# Technical Bulletin

## Torque Specs for Direct™ Plus, Flex, and Max

### Preventative Maintenance Torque Check

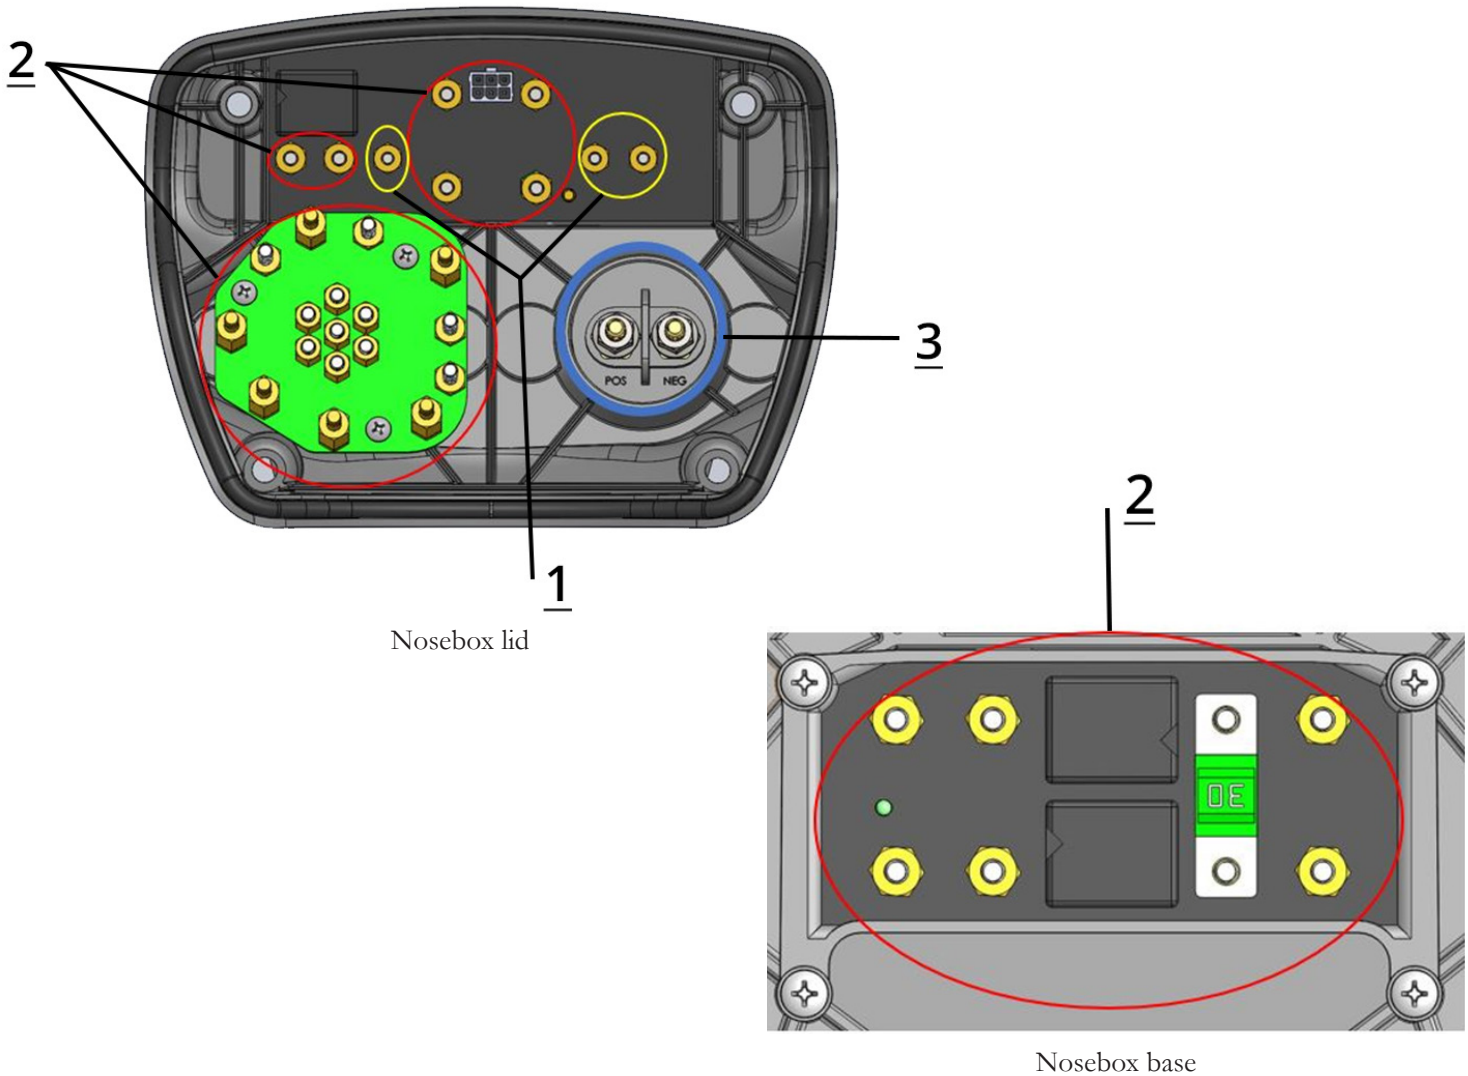
Purkeys would like to suggest that on all preventative maintenance checks or repairs to a Direct Plus, Flex, or Max, all threaded stud junctions be checked for proper tightness, as the nuts may loosen over time. To reduce the chance of loose fasteners, Purkeys has changed the design to incorporate Nylok nuts in future products.

The stud junctions shown below need to be checked. The minimum recommended torque specs are:

Call-out	Size	Recommended torque
1: circled in yellow	8/32	36 inch-lbs
2: circled in red	10/32	48 inch-lbs
3: circled in blue	1/4-20	60 inch-lbs
